Shell Canada Limited

**Applications for an Oil Sands Mine, Bitumen Extraction Plant,
Cogeneration Plant, and Water Pipeline in the
Fort McMurray Area**

February 5, 2004

**REPORT OF THE JOINT REVIEW PANEL ESTABLISHED BY THE
ALBERTA ENERGY AND UTILITIES BOARD AND THE GOVERNMENT OF CANADA**
Decision 2004-009: Shell Canada Limited, Applications for an Oil Sands Mine, Bitumen
Extraction Plant, Cogeneration Plant, and Water Pipeline in the Fort McMurray Area
February 5, 2004

Figure 1. Shell Jackpine Mine and surrounding area

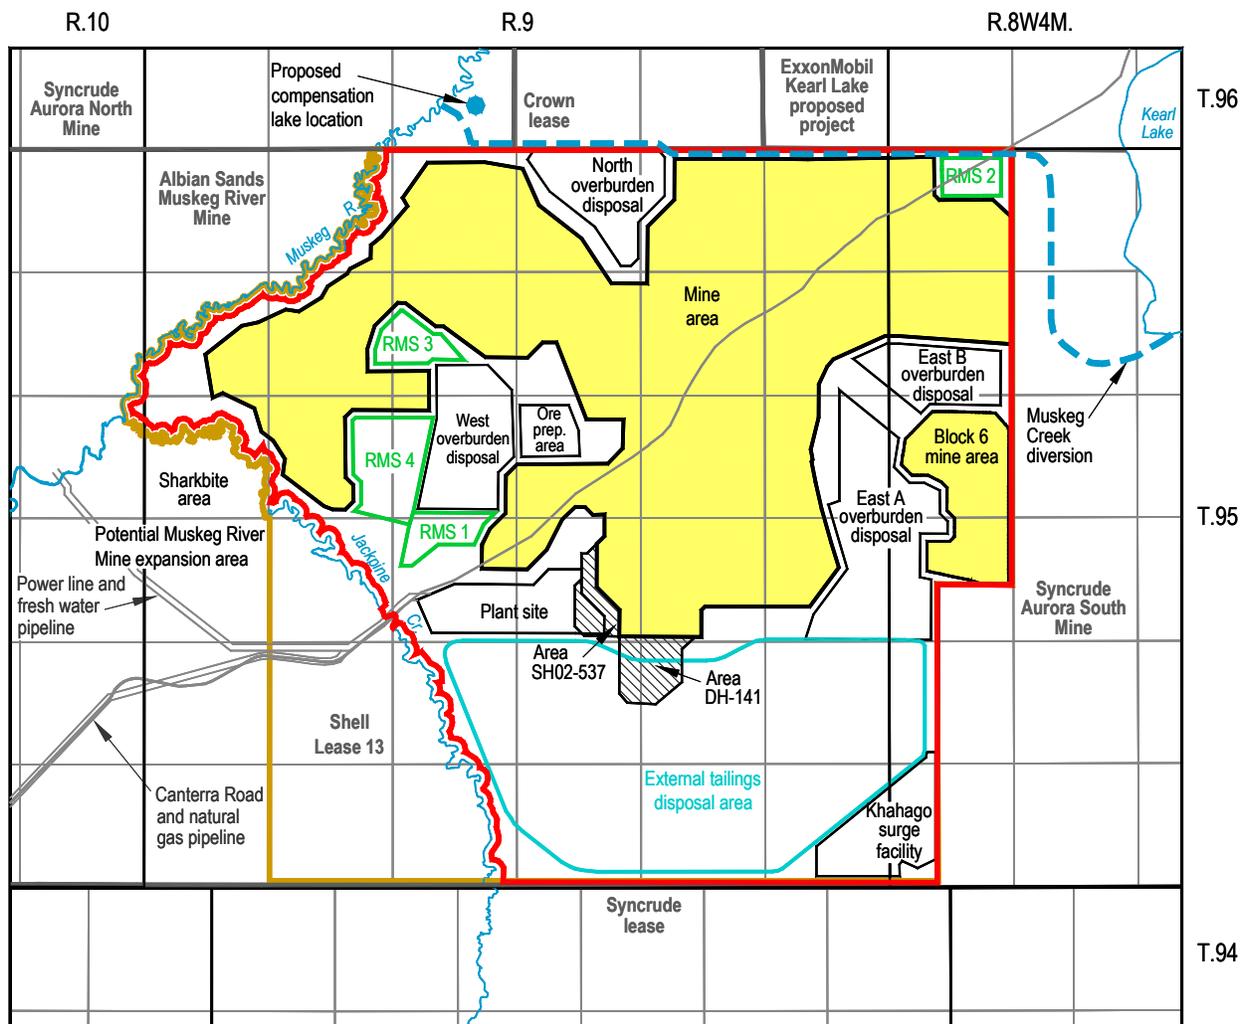
A marginal pit expansion area, denoted as SH02-537, would encroach on the plant site footprint. Shell's evaluation indicated that area was not economic to mine (Figure 1). However, Shell stated that it would complete additional resource drilling along the pit limits in the area prior to finalizing the footprint limit of the plant site.

The Panel notes that additional drilling in the Sharkbite area will provide further understanding of the mineable oil sands zone. It notes that there is a possibility that the current access route may change as a result of Shell and Syncrude working together to find a suitable access route to the project and the Syncrude Aurora South Mine. The Panel also notes that Shell is participating in RIWG's Transportation Subcommittee, which includes other oil sands developers, Alberta Transportation, and the Regional Municipality of Wood Buffalo (RMWB), to find alternatives to the Canterra Road. The Panel further recognizes that significant changes to the Canterra Road will not occur until 2007. Therefore, the Panel believes that the proposed utility corridor and access route could potentially be modified. Those modifications would need to be considered from a number of aspects, including resource recovery.

The Panel believes that there is sufficient time to acquire the information required to optimize the recovery of mineable oil sands in the Sharkbite area and the location of the access road and utility corridor for the project. The Panel, therefore, directs Shell to submit, for EUB approval, an access road and utility corridor update in its 2006 annual report. The report shall include a resource assessment of the oil sands located in the Sharkbite area and under the modified infrastructure corridor. It shall also include a comparison of alternative access road and utility corridor alignments with respect to resource recovery and other relevant criteria.

The Panel believes that the plant site footprint is sufficient for the proposed project. However, the Panel will require Shell to obtain EUB approval should the plant site area need to be larger. The Panel directs Shell to submit, for EUB approval, a resource assessment of the plant site area two years prior to construction.

Shell identified a marginal mining area, denoted as area DH-141, which encroached on the northwest corner of the tailings disposal area, but stated that this area was not economical to mine. Shell stated that while it did not provide the results of combining area DH-141 and SH02-537, work that was completed resulted in a higher combined TV:BIP value than that of either of these pit extensions on their own. SH02-537 was a marginal zone that encroached on the plant site. Shell said that it would complete drilling along the pit limit near the plant site and tailings disposal area prior to finalizing the footprint of either of the sites (Figure 1).

Figure 2. Muskeg River watershed

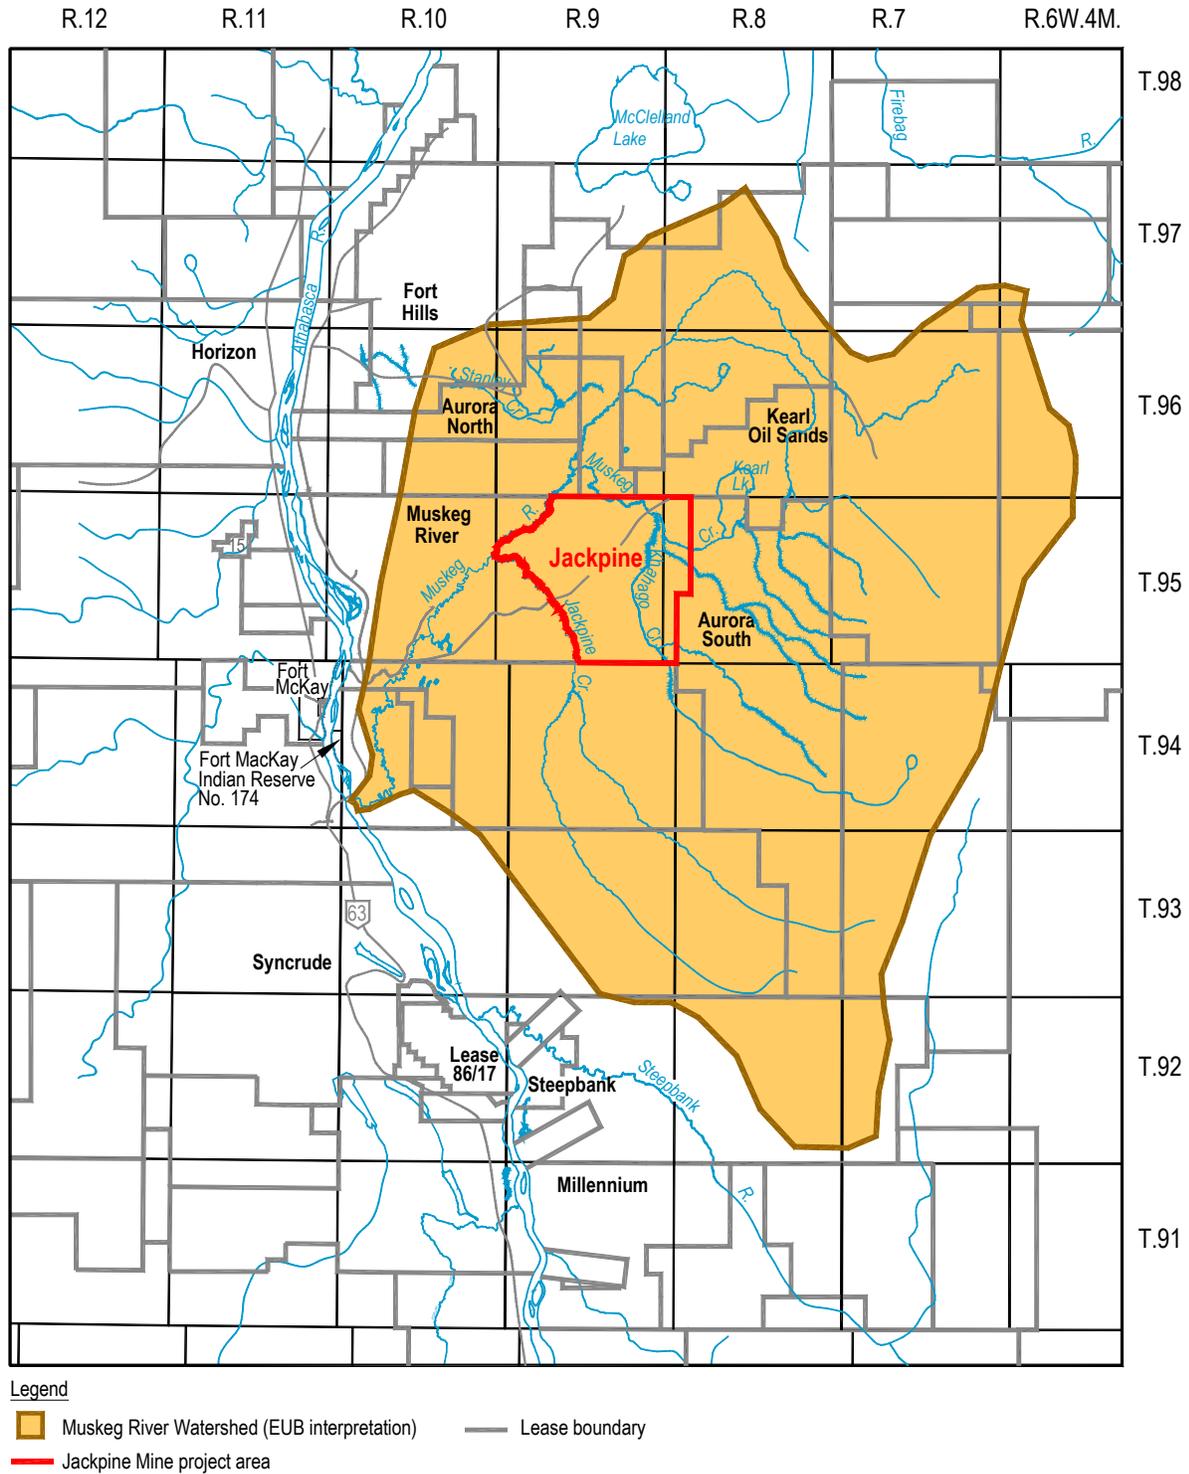
Shell studied seven creek diversion alternatives representing the technically viable options for each creek (see [Figure 2](#)). The Khahago, Muskeg, Wesukemina, Shelley, Pemmican, Green Stocking, and Blackfly Creeks would be affected in the project area.

Shell stated that several tributary streams of the Muskeg River would be disturbed or excavated during the course of the project. [Figure 2](#) shows the area of the Muskeg River drainage basin and some tributaries of the Muskeg River. Surface waters from seven tributary streams of the Muskeg River would be affected by mining. A new outlet to Kearl Lake and the Khahago surge facility would be constructed. Jackpine Creek would remain essentially unchanged, as it had high value for fish habitat. At mining closure, three large EPLs were planned, two of which would contain water-capped tailings. The lakes would function for flow attenuation and bioremediation of flows from reclaimed lands.
